**Service Letter #:** SL06-36-70008

**Part/Assembly #:** 36-70008/Supplemental Airplane Flight Manual (SAFM) A-10011 – all previous.

**Float Model Affected:** Aerocet Model 3500 and 3500L on Cessna 206 Aircraft (STC SA00003SE) (All before 8/1/13)

**Figure 1 Showing correct verbiage from SAFM**

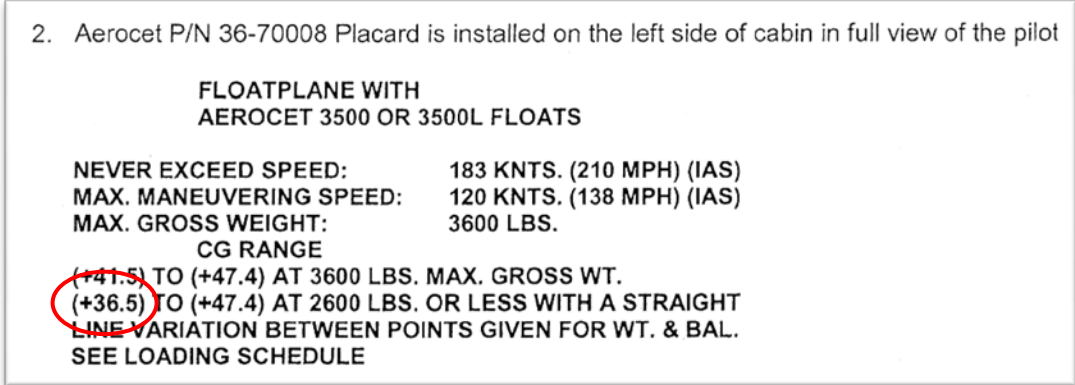
**Symptom:** Typographical Error on Aerocet supplied placard: light, forward CG may be incorrect. Flight Manual Supplement A-10011 has correct limitations.

**Corrective Action:** Please check your installation against the SAFM. Replacement placards are available through Aerocet or you can correct your existing placard by any permanent means.
